**SAN ANTONIO WATER SYSTEM
CENTRAL WATER INTEGRATION PIPELINE
MALTSBERGER PUMP STATION IMPROVEMENTS
SAWS Job No. 18-8617
SAWS Solicitation No. CO-00190**

**ADDENDUM No. 3
August 30, 2018**

SAN ANTONIO WATER SYSTEM
CENTRAL WATER INTEGRATION PIPELINE
MALTSBERGER PS IMPROVEMENTS
MALTSBERGER PS
YARD PIPING PROFILES

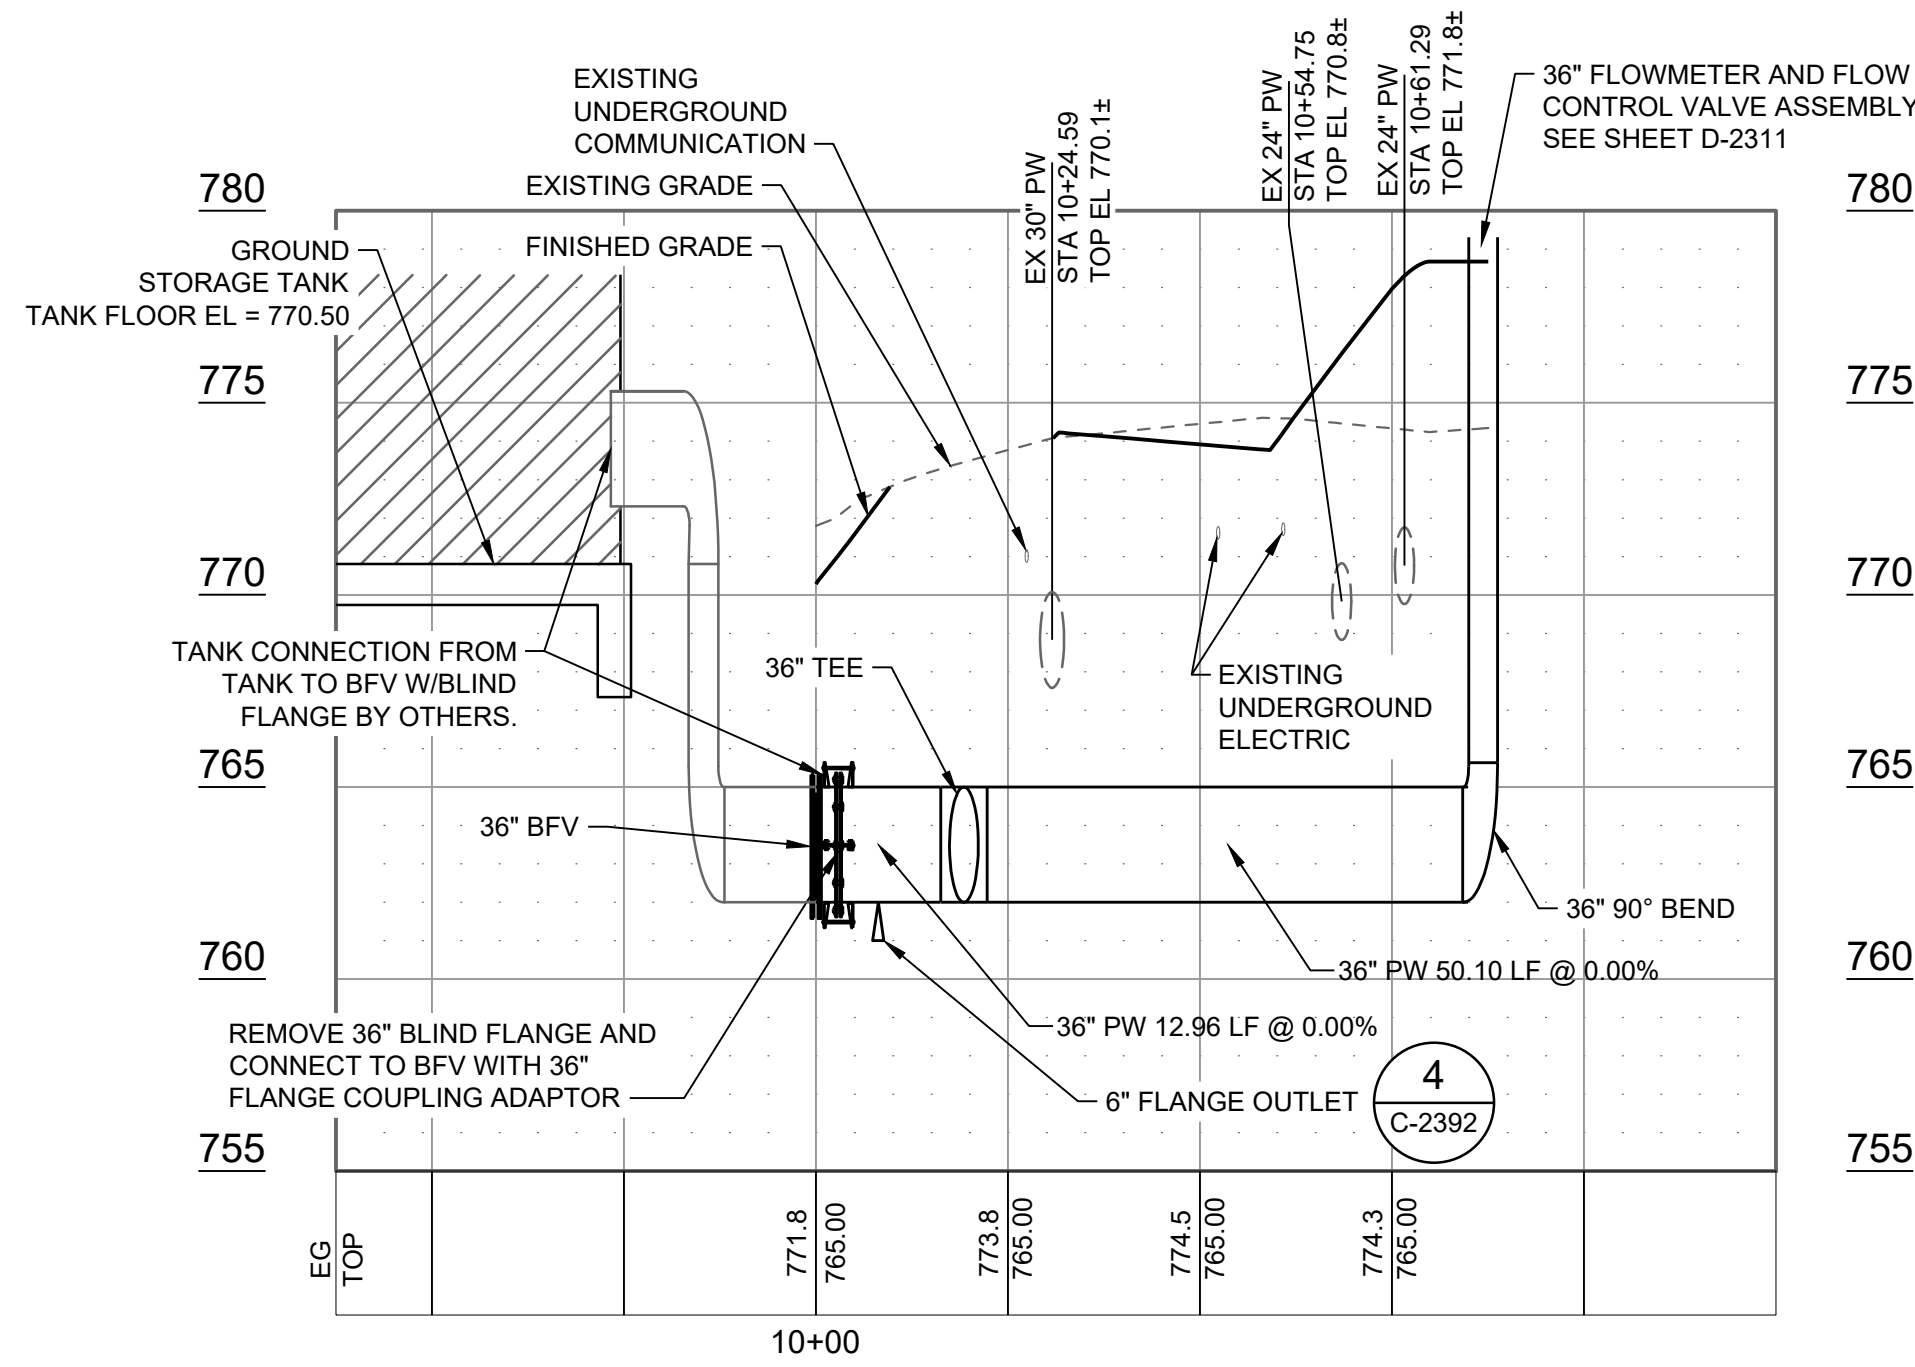
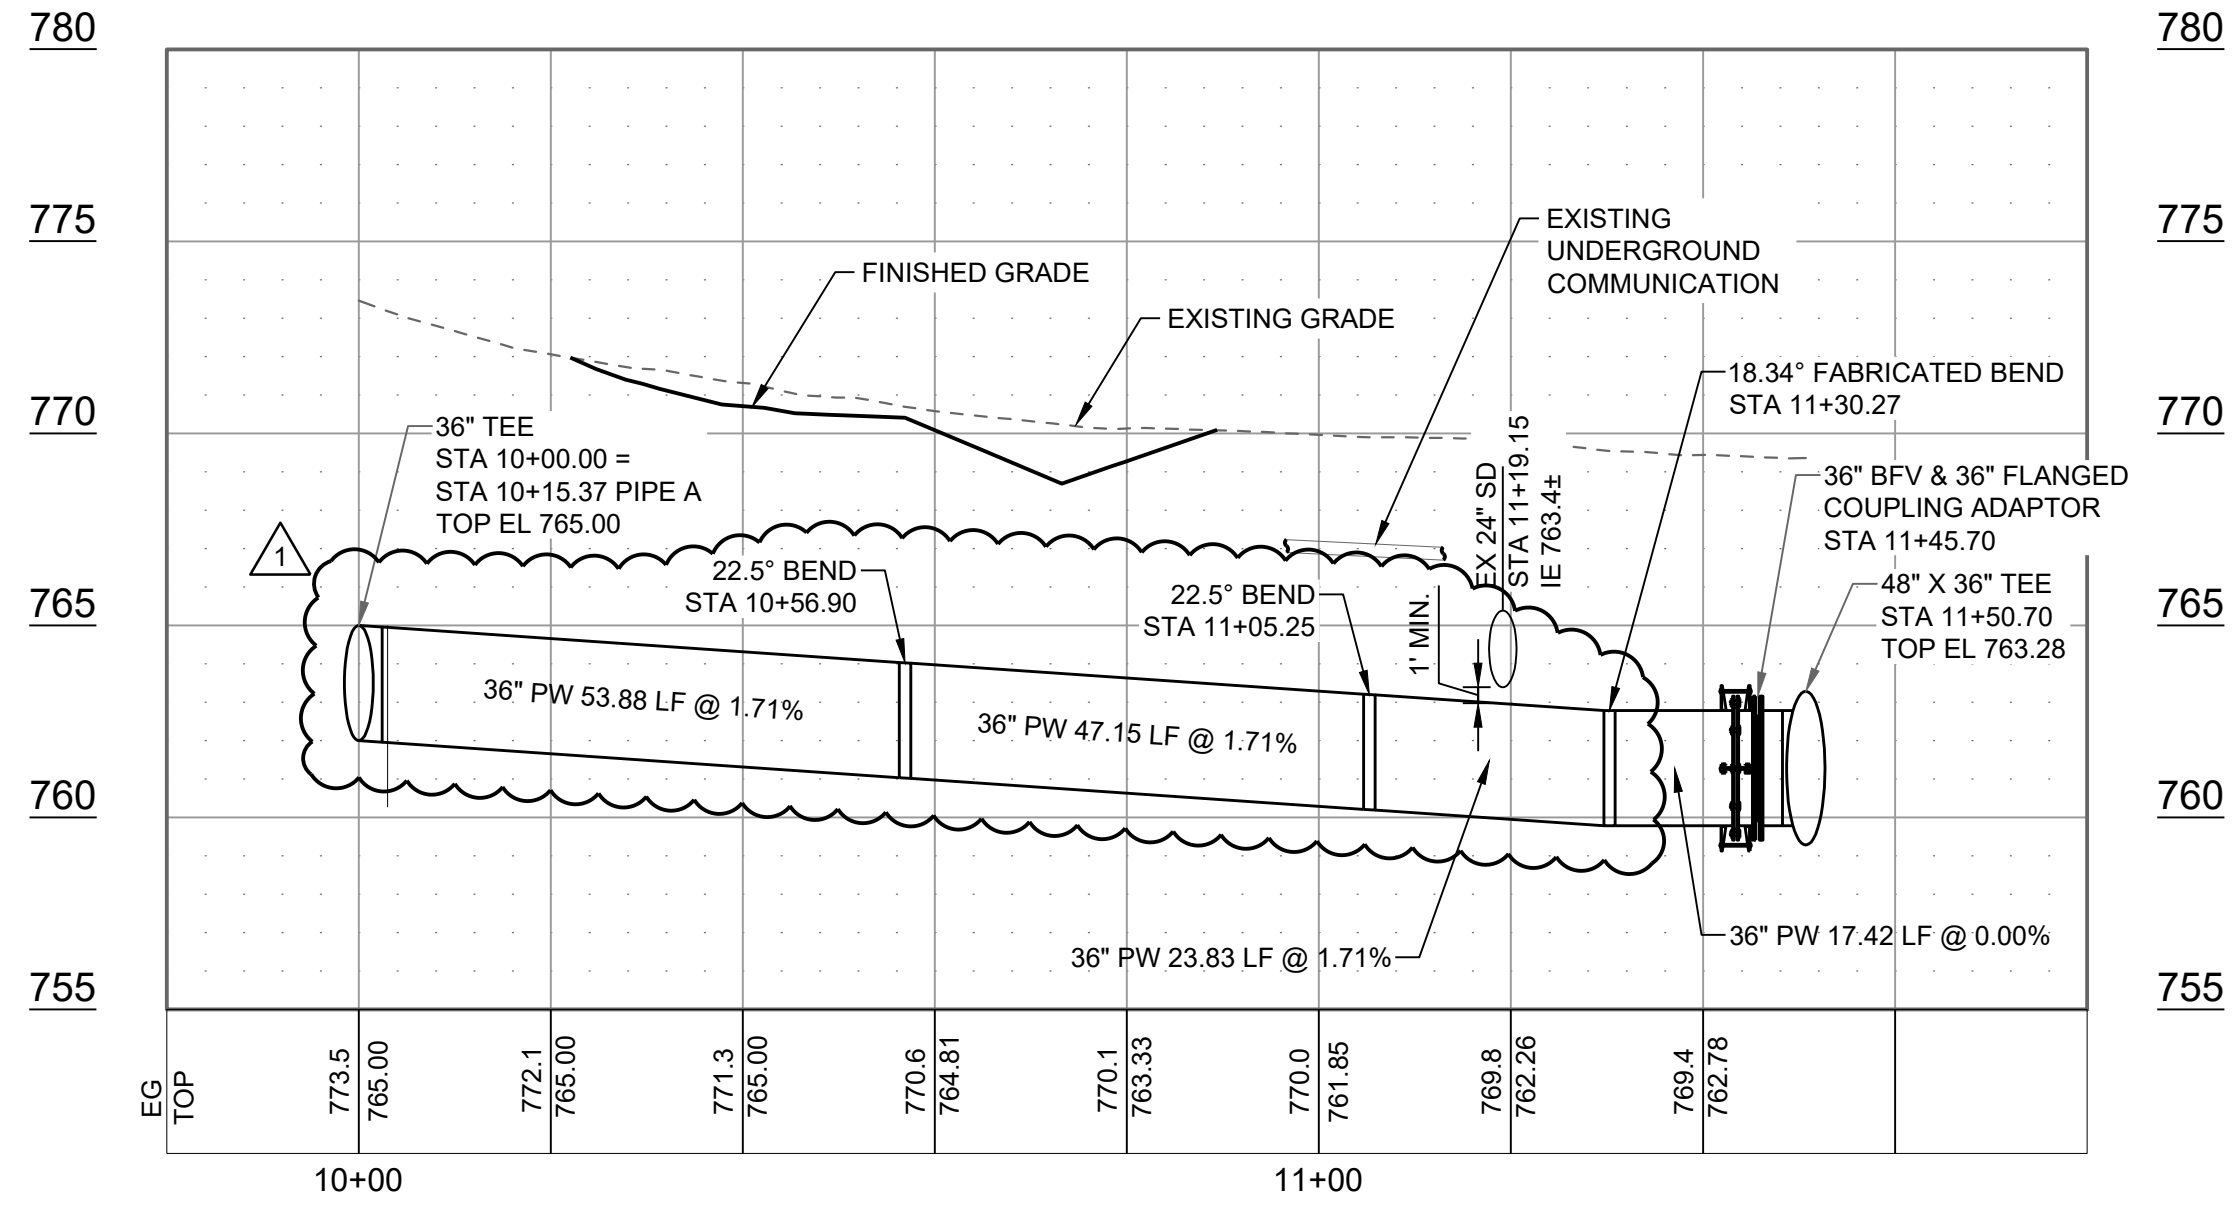
8	Ref Plan Page C-2318. Pipe C Drain. This is one the schedule as a 6" PVC SDR26 HW Sewer Pipe. Detail 4/c-2392 shows this piping as ductile iron pipe. Can you verify what pipe material should be used for Line "C"	This line has been removed per addendum 3.
9	Plan sheet E2304, keynotes 4, 5, 6 refer to the installation of a new gate controller, and a new gate. The gate is also indicated on plan sheet C2312, and an installation detail is shown on plan sheet E2392. However, we cannot locate a specification for the gate operator equipment and accessories. Please provide us with one.	Specification Section 02821 Chain Link Fences and Gates was replaced in Addendum 2 with the gate requirements.
10	Please refer to plan sheet E2391, detail 1, "concrete reinforced duct bank section". This detail does not indicate steel rebar stirrups as being required. However, detail 7 "below grade duct entrance detail" appears to indicate rebar stirrups. Are rebar stirrups required? If so please provide us with the rebar size, spacing, and overlap requirements.	Rebar stirrups will be required. This is reflected in the changes to SHEET E-2391 per Addendum No. 3.

20	Can you clarify the type of pipe required for the 6" Pipe C? Pipe Schedule for D (drain) lines says SDR 26 PVC but the detail referenced (4/C-2392) shows ductile iron. You don't have a ductile iron spec which we will need regardless.	This line has been removed per Addendum No. 3.
21	Section 01600, paragraph 1.11 appears to be information for a different project. Please confirm/correct.	This will be corrected in a future addendum.
22	On sheet C-2317 in grid areas C4 and E5 there are callouts for 2" tee and ball valve per detail 6/C-2392. These injection points connect to a line labeled '2" CWS' that runs between the two injection points. First, what diameter pipe are the injection points being installed on? Second, is the 2" CWS pipe a new line that the contractor needs to install? The line isn't called out as existing, but it also isn't drawn with a bold line like the other proposed pipe are.	Chlorine solution injection is needed for shutdown condition with pumps 5, 6 and 7 in operation and 1-4 isolated. Piping system is 2" Red Horizon 200 Synthetic tubing as manufactured by Goodyear. Connection will be made in the existing vault to an existing 2" tubing labeled "spare" and extended to a direct buried injector (see detail 6 on sheet C-2392).

CHLORINE INJECTION POINT

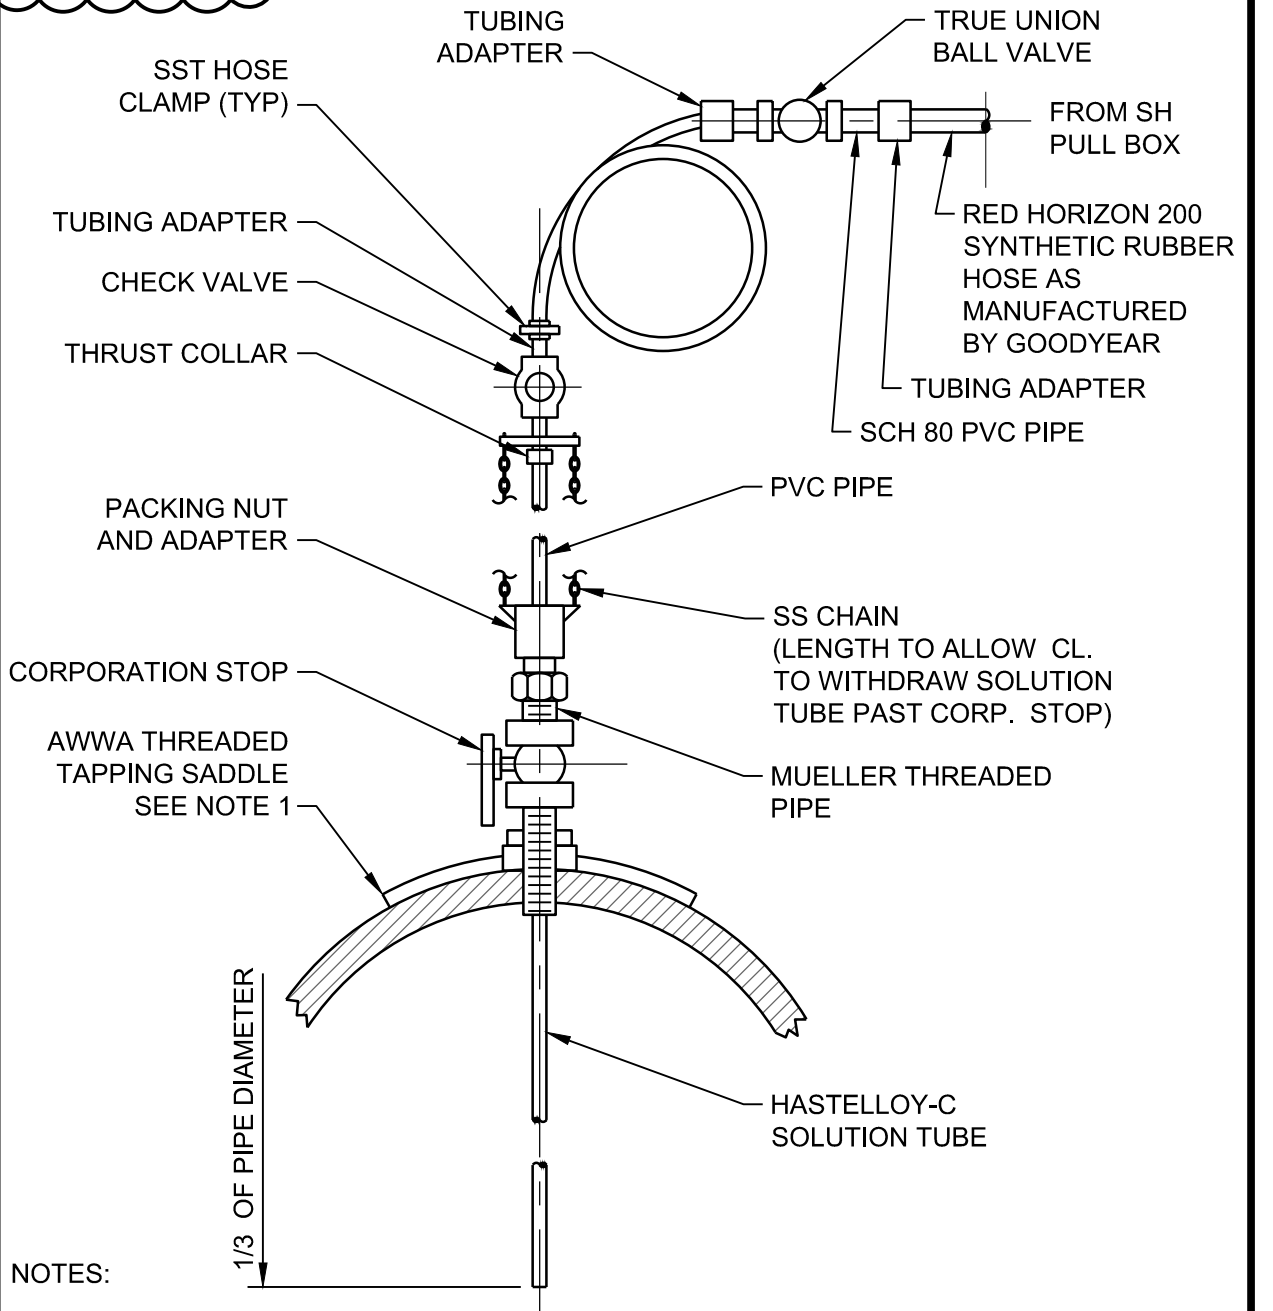
6	Ref Plan Page M-2306. The connection to 24" HDPE Pipe. Can you provide a specification/detail for the 24" Transition coupling (HDPE to DI). Can you also verify the existing Pipe OD's for the 24" HDPE Pipe (DIPS or IPS).	Connection between HDPE and DI should be done according to SAWS specifications, contractor should use HDPE MJ Adaptor with stainless steel stiffener insert. Contractor is responsible to excavate and field verify pipe OD's, before ordering connections. According to SAWS as-builts, the HDPE supplier was CP CHEN PERFORMANCE PIPE (CHEVRON PHILLIPS CHEMICAL COMPANY LP)
7	Ref Plan Page C-2317. There is a 2" CWS Line on the east side of the Existing Ground Storage Tank. This line has a detail for a tee & ball valve on both connections. They Reference Detail 6/C-2392. This is a detail for a below ground injection point. I'm not quite understanding how we'd have an injection point on both ends? Can you please verify these details. We also need a pipe system for the 2" CWS Pipe.	Piping system is 2" Red Horizon 200 Synthetic tubing as manufactured by Goodyear. Connection will be made in the existing vault to an existing 2" tubing labeled "spare" and extended to a direct buried injector (see detail 6 on sheet C-2392).

1 ELECTRICAL BUILDING POWER PLAN

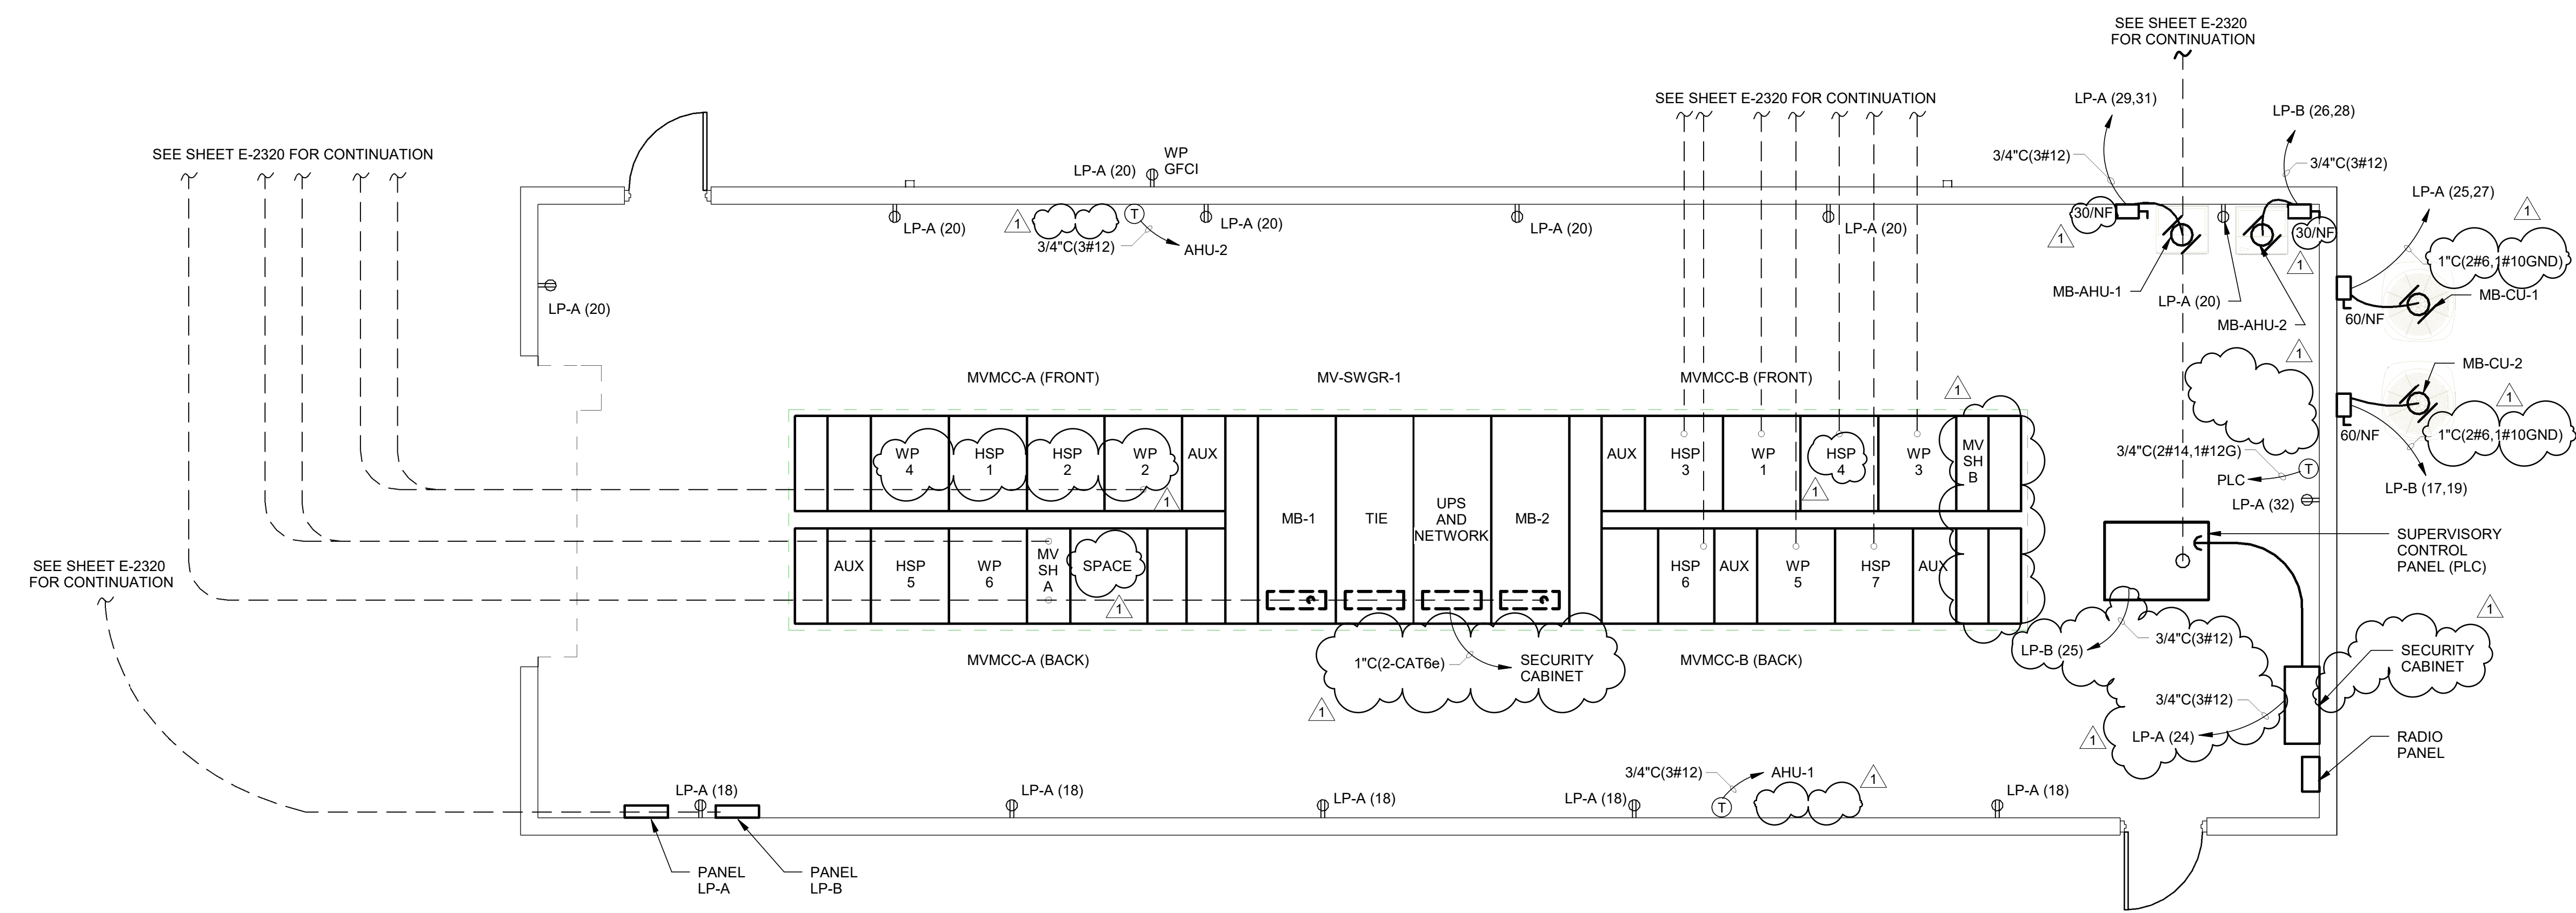
34	Sheet E-2321: Please revise and identify proposed electrical raceways, contents, and electrical items.	Updated plan is provided. This is reflected in the changes to SHEET E-2321 per Addendum No. 3.
35	Sheet E-2322: Please revise and identify ALL light fixtures.	Light fixture schedule will be provided in a future addendum.
